TASCAM
TEAC Professional Division

CD-RW2000

SUPPLEMENT

The circuit diagrams here are applicable for CD-RW2000 S/No. 0390001 and higher.
Use this with the original CD-RW2000 Service Manual, Effective: June, 2000.

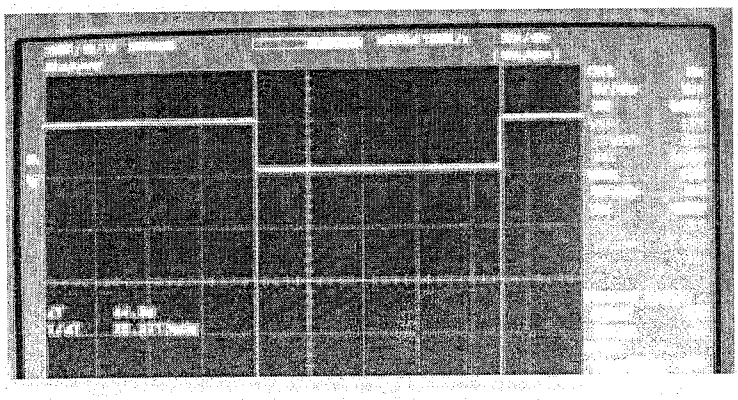
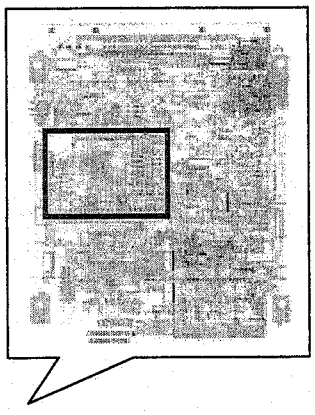
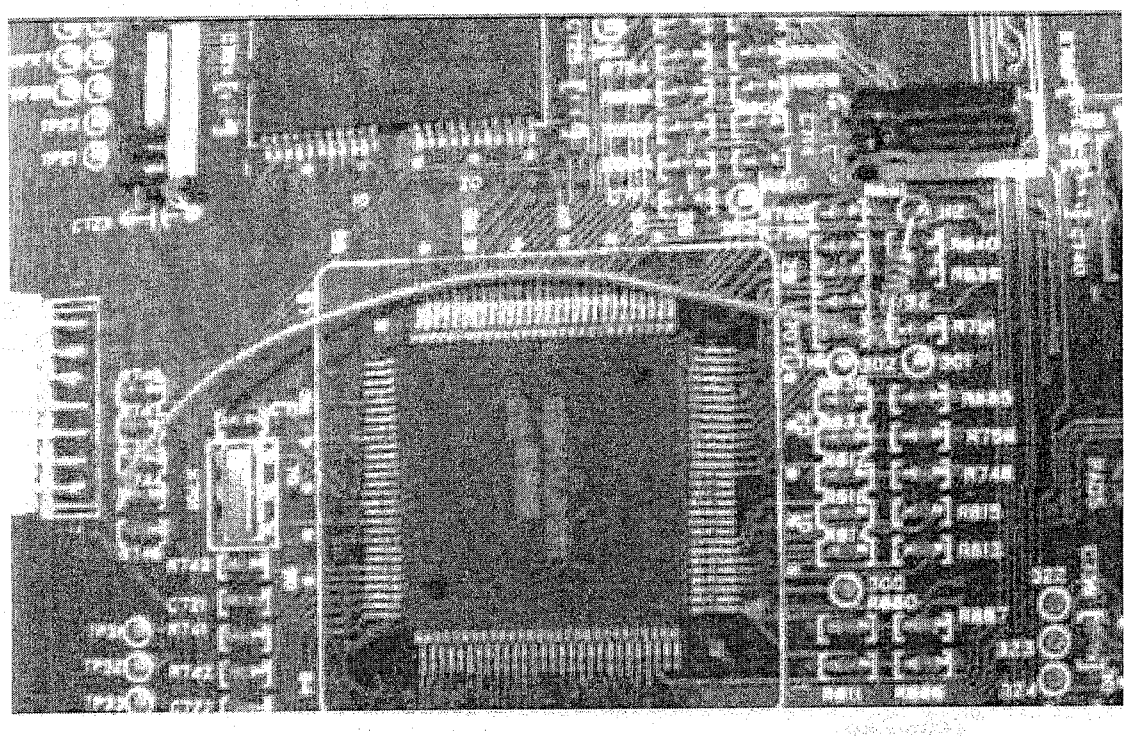
A temporary work on the Converter PCB Assy to connect an oscilloscope is required to realize a successful completion. This is since the Converter PCB Assy of CD-RW2000V3 does not have necessary hardware to continue to show update sequence further. The waveform becomes Low when the **ENTER** key is pressed and goes to High approximately 45 seconds later upon end up the update as shown below:

The point to observe the waveform is a junction of additional 1kohm resistor and 60 mm wire that is connected across pin 30 (TP312) and pin 77 (R744) of the MPU (U707) as shown above.
